Date: **June 7, 1999**

Subject: **CORRECTING BLACK HORIZONTAL STRIPE NOISE**

Model: **BVM-8044QD, BVM-8045QD**
PVM-8040, SSM-8040

Figure 1

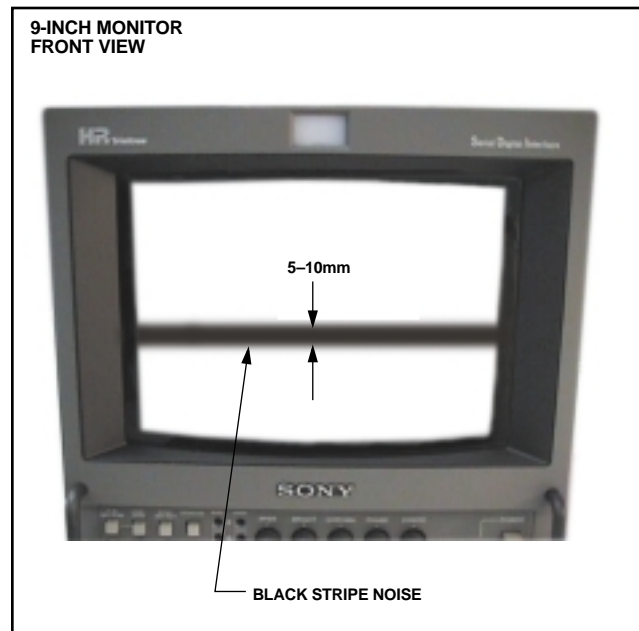
If the high voltage cable retaining disk touches inductor L506 on the D board, 5 to 10mm wide black stripe noise may periodically appear on the 9-inch monitor screen for 0.1 to 0.2s. (See Figure 1.)
